RE: Mast Tuning, Hulls No. 237 and Lower

FROM: Catalina Yachts, Engineering DATE: April 23, 1992, E.B. No. 29

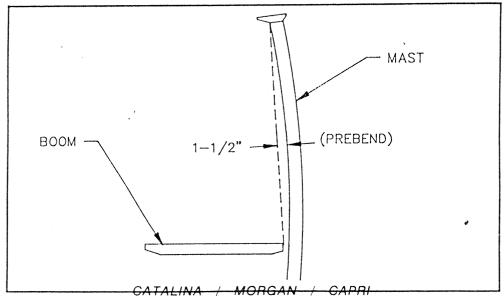
On some recent model Capri 26's it may be difficult to achieve the required prebend bow forward in the center of the mast as illustrated below, or the mast may bow aft in the center when the shrouds are tensioned and cannot be eliminated by adjusting rigging wire tension.

A mast bow aft can be corrected by adding a shim under the mast step.

Capri 26 owners who have had difficulty tuning the rigging or have an aft bow in the mast may request a mast step shim and installation instructions, at no charge, from Catalina Yachts.
